File Number: 2-G-25-IH

**Meeting:** 4/16/2025  
**Applicant:** Kelsey Chambers Dave Madden Architects  
**Owner:** Antares LLC  
**District:** Lonsdale Infill Housing Overlay District

**Location:** 3335 Divide St. **Parcel ID:** 81 P B 003  
**Zoning:** RN-2 (Single-Family Residential Neighborhood)  
**Description:**  
New primary structure

Level III New Primary Structure

Title: SITE PLAN

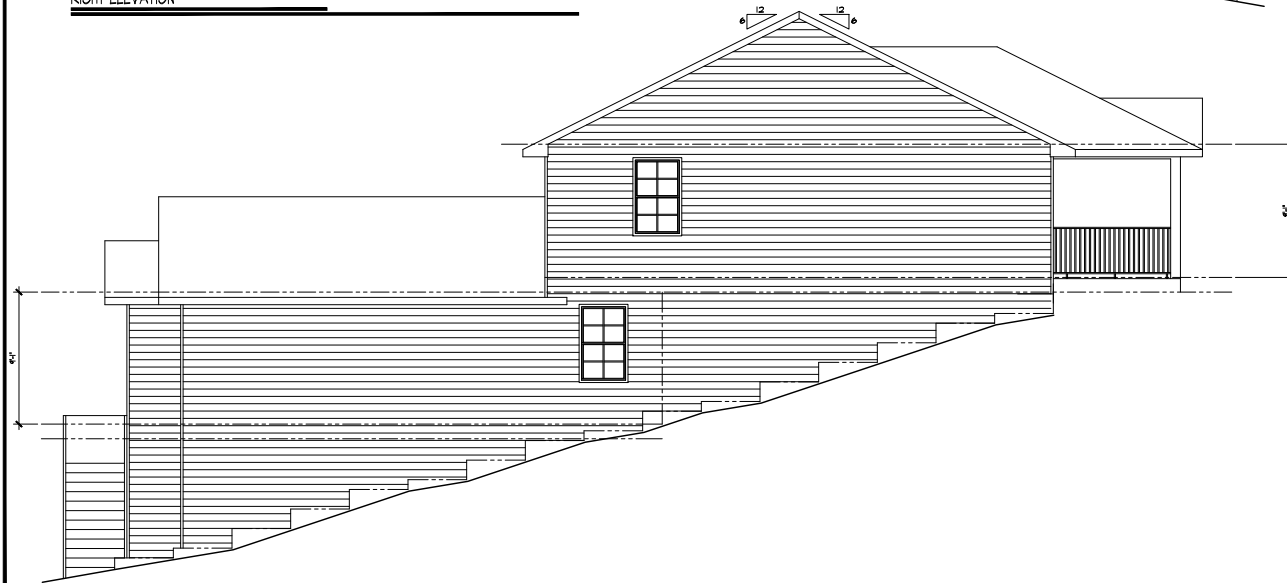
1. The house is proposed to be set 37'-3" front the front property line. The average front setback of the block is 41'. The adjacent houses are set significantly back, at 70' and 79'. The proposed front setback will be similar to the other new houses and will be more in line with the block. The final site plan should be revised so that the front walkway connects to both the street and the driveway.

3. Infill Housing design guidelines recommend that on lots without alleys, new driveways should be at least 20' behind the front façade of the infill house with access limited to one lane between the street and the front façade. Parking can also be accessed from the rear street on through lots. Parking is a concrete pad located in front of the house and accessed via a driveway from Divide Street. Parking should be revised to avoid the front yard. The final site plan should meet City Engineering standards.

9. The final site plan should be revised to include a native or naturalized shade tree in the front and rear yards. Guidelines state that "Healthy trees that are outside the building footprint should be preserved." The remaining trees in the rear yard should be retained and indicated on the site plan, unless revisions to the parking location make removal necessary.

Staff recommends approval of Certificate 2-G-25-IH, subject to the following conditions: 1) the final site plan to meet City Engineering standards; 2) parking location to be revised to avoid the front yard; 3) the final site plan to include a walkway to the street; 4) foundation to be clad in stucco or parge-coated, and siding to be lap siding with an overlap, as opposed to Dutch lap, flush panel, or board-and-batten siding; 5) the final site plan to include a native or naturalized shade tree in the front yard and rear yard, and the remaining trees in the rear yard should be retained if at all possible.

**ELEVATIONS**

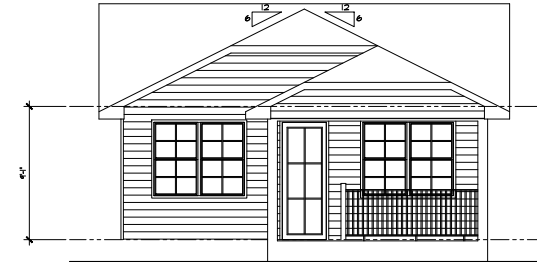
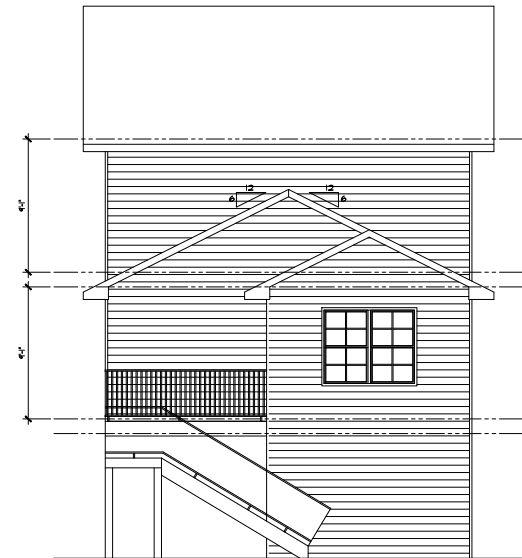
4. The one-story, three-bay façade on the front elevation is similar in scale and height to the context. No other houses on the block feature an additional basement-level massing, but those lots are not steeply sloped.

6. Guidelines recommend window and door styles be similar to historic houses on the block, with similar placement and ratio of solid to void. The 4/4 single-hung windows are compatible with the 6/6 single-hung windows on most houses in the block, and all elevations except the left elevation feature a sufficient ratio of solid to void. The left elevation will be minimally visible from the street due to small setbacks, but it features large swaths of blank siding, particularly on the rear massing. The Board should discuss whether an additional window on the left elevation of the rear massing is necessary.

8. The asphalt shingles and vinyl horizontal siding meet the design guidelines. The foundation appears to be a concrete block, which should be clad in stucco or parge-coated to meet the design guidelines. The final siding material should be lap siding with an overlap, as opposed to Dutch lap, flush panel, or board-and-batten siding.
